S4.55(2) MODIFICATIONS - GROUND LEVEL

NEW HOSPITALITY VENUE  
PARRAMATTA  
FOR CASTLE HILL RSL CLUB

TITLE  
GROUND FLOOR PLAN

S4.55(2) MODIFICATIONS - FIRST FLOOR

#### S4.55(2) MODIFICATIONS - SECTIONS

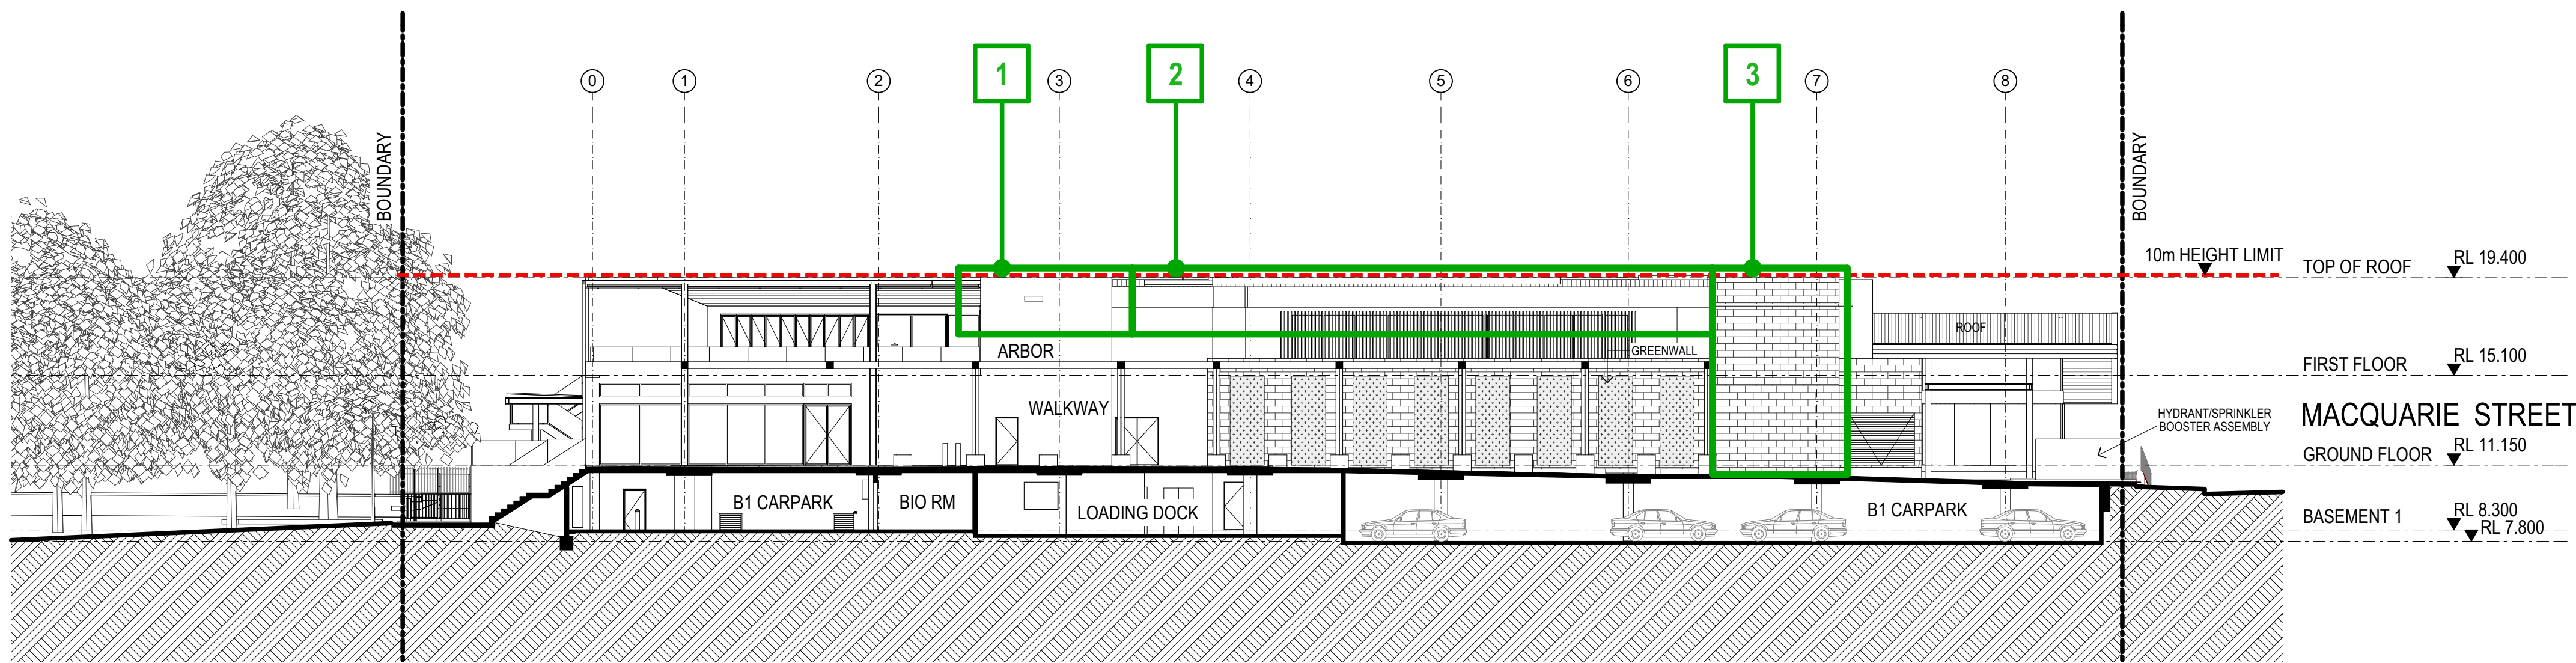
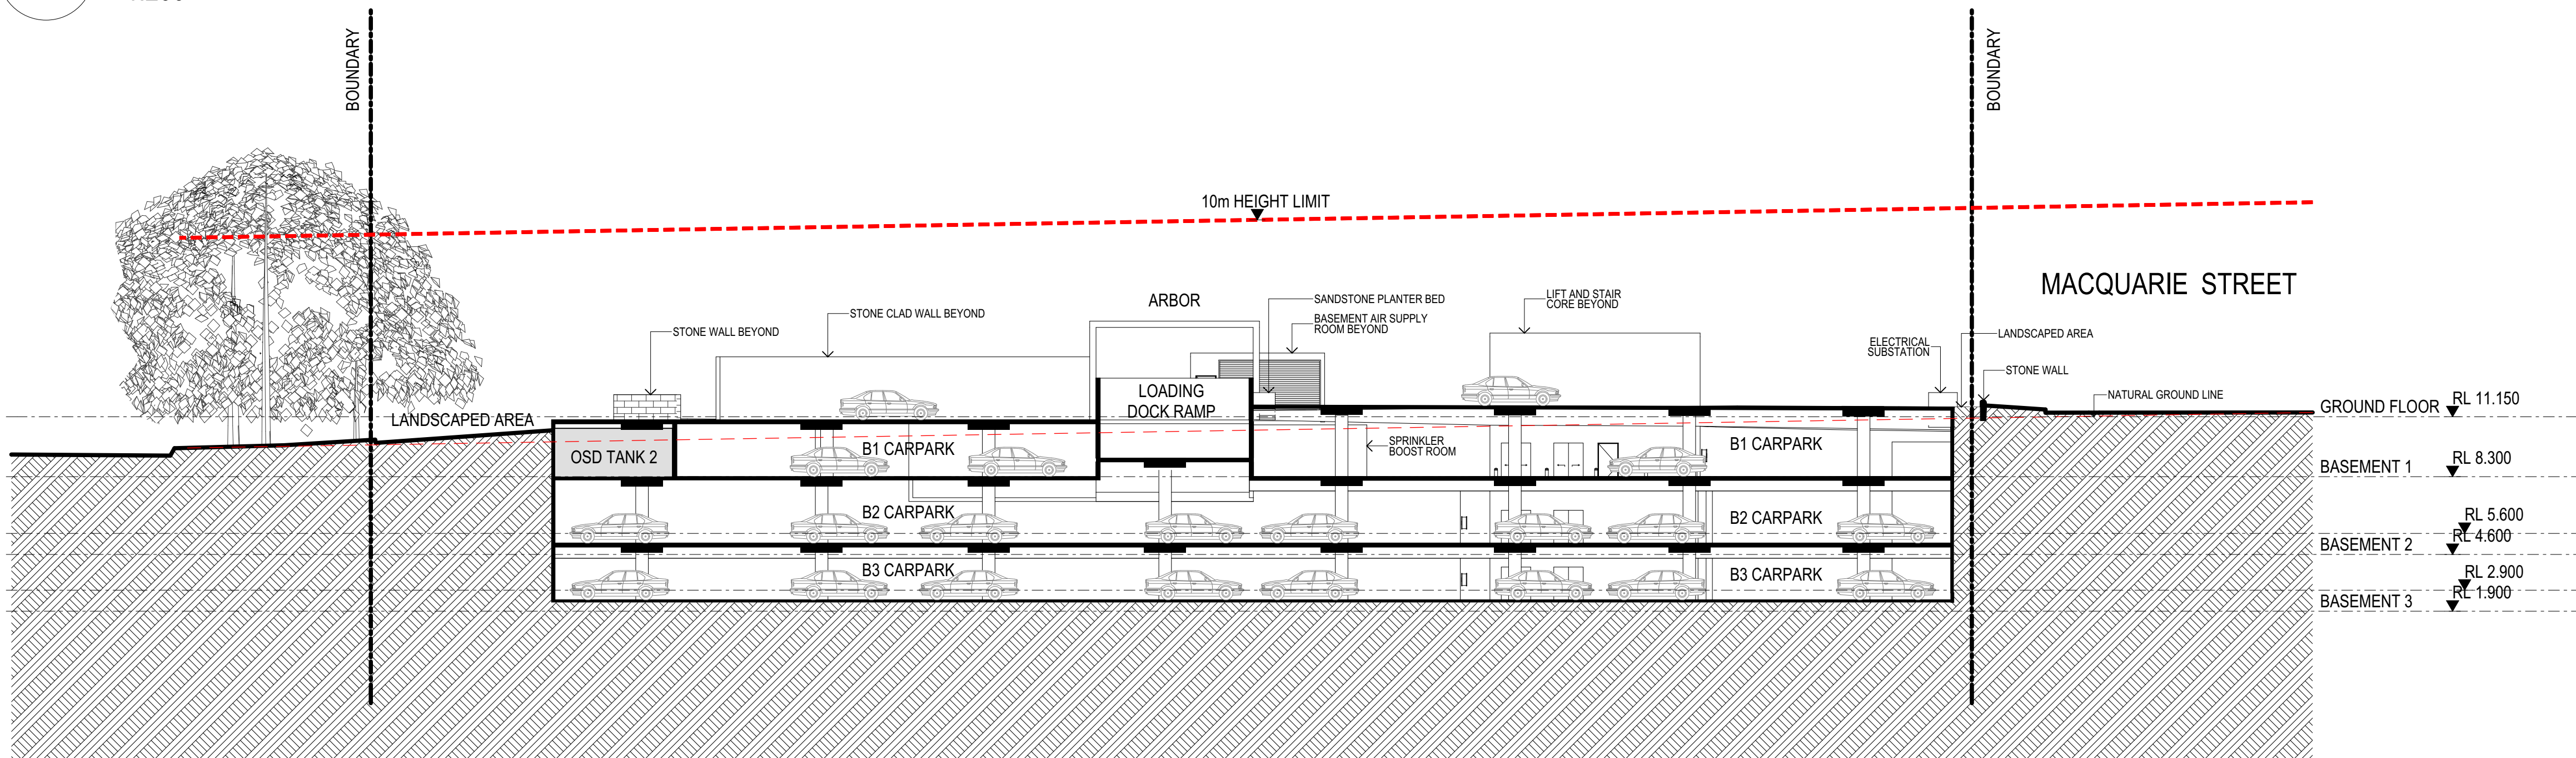
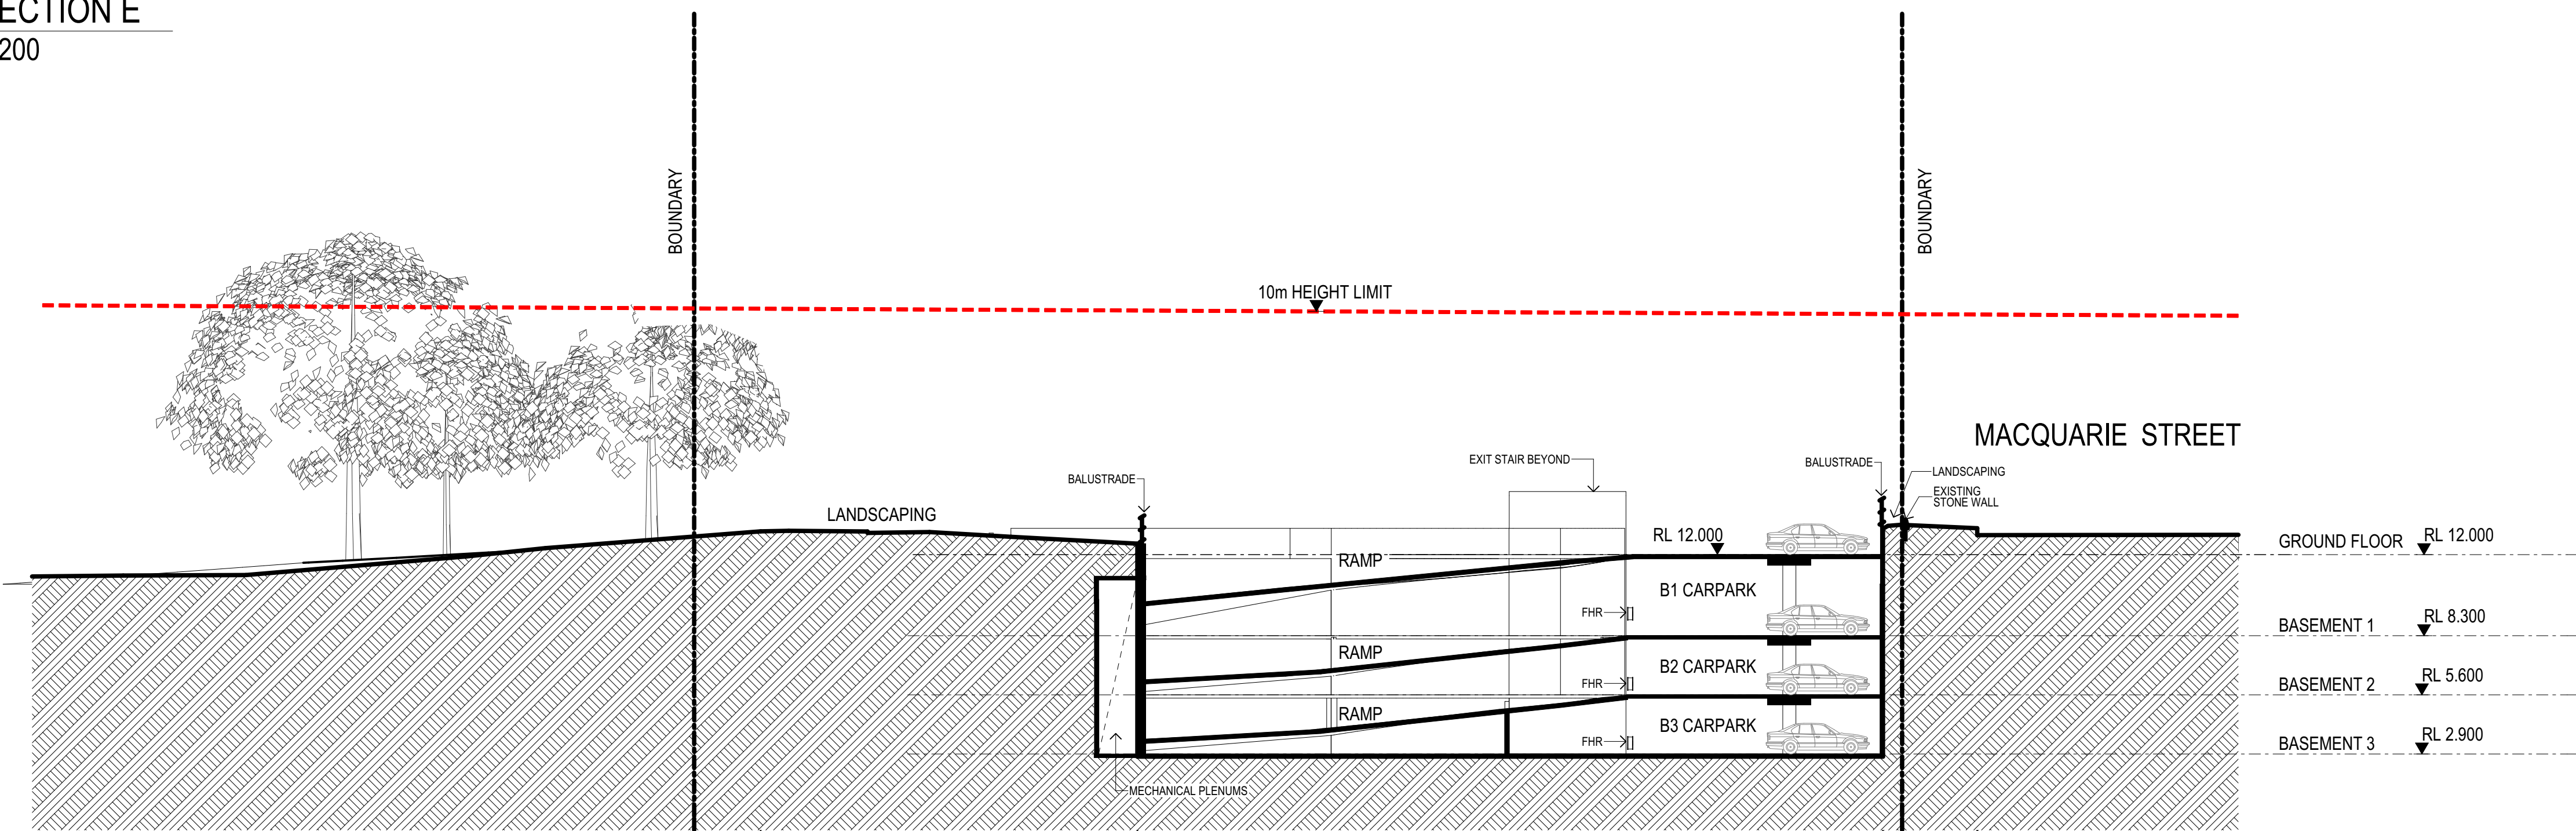
- EAVES REMOVED, EXTERNAL WALL RAISED TO FORM PARAPET
- FIRST FLOOR EXTENSION TO ACCOMMODATE FUNCTION ROOMS
- ADDITION OF EGRESS STAIR FROM FIRST FLOOR TO GROUND LEVEL TO SERVICE NEW FUNCTION ROOMS.
